Subject: RE: Commerce Street Plume driveway

I am writing to respond to the inquiry that I received from John Kelliher, on your behalf, regarding proposed construction of a driveway on a new/revised easement that runs along the northern portion of the property at 96 Commerce Street, Williston, Vermont (Lot 07:019:011000) (the Property). The Property is located within the Commerce Street Plume Superfund Site (the Site). EPA's cleanup plan for the Site is detailed in the Record of Decision (ROD) issued in September 2015, a copy of which can be found at: <a href="http://semspub.epa.gov/work/01/582994.pdf">http://semspub.epa.gov/work/01/582994.pdf</a>. On July 27, 2015, EPA sent you notification of your opportunity to comment on its proposed cleanup plan.

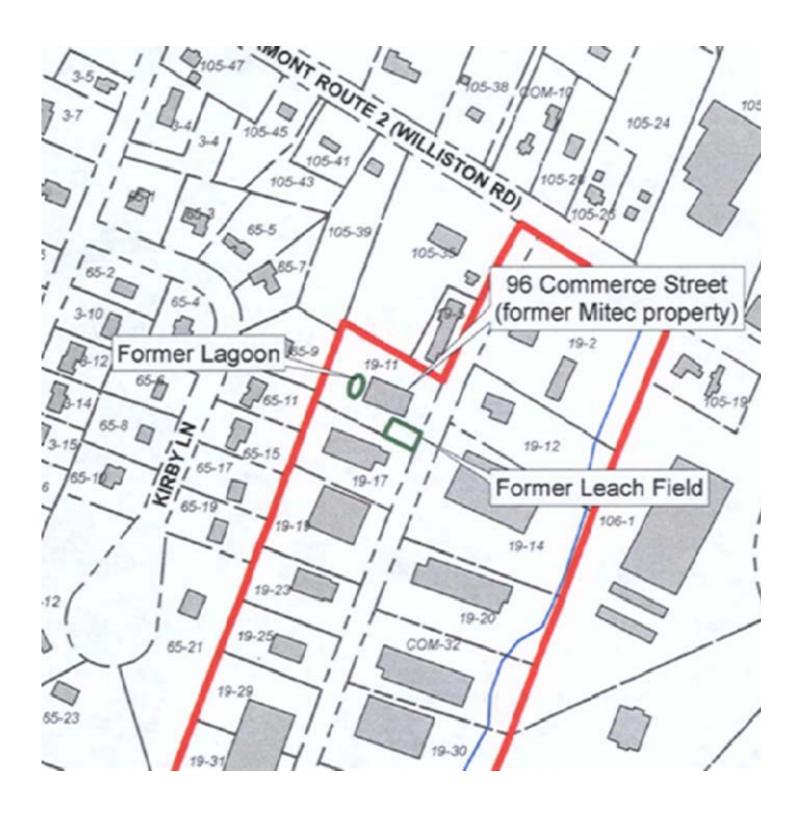
Prior to construction of the driveway, you have proposed a sampling program consisting of five soil samples collected from two feet below grade at the locations marked on the attached. The samples are to be analyzed for hexavalent chromium and compared to promulgated standards in order to determine if the material is appropriate for use as borrow. Through this email, EPA neither approves nor disapproves of your proposed improvements, work approach or sampling plan. I do offer, however, the following comments for your consideration based on my knowledge of the Site:

- 1. In addition to hexavalent chromium, analysis of the soils should also include PAHs and arsenic, which also contribute to human-health risk associated with the Property.
- 2. Data analysis should include a comparison to the residential, risk-based soil cleanup levels that EPA selected in the 2015 ROD, as shown in Table L-1. Soil that exceeds EPA's cleanup levels should not be used as borrow, but instead be disposed of properly off-site in compliance will all federal, state, and local laws. Please note that materials removed may be contaminated with hazardous substances and subject to RCRA, and therefore require proper characterization, identification and off-site disposal at a licensed disposal facility.

- 3. Given the distribution of contaminants found on the Property, an additional soil sample from the 6" to 12" below grade interval from each of the five proposed locations should be added to the program.
- 4. A robust health and safety plan that presumes that field personnel will be in contact with soil containing hexavalent chromium, PAHs and arsenic should be implemented.
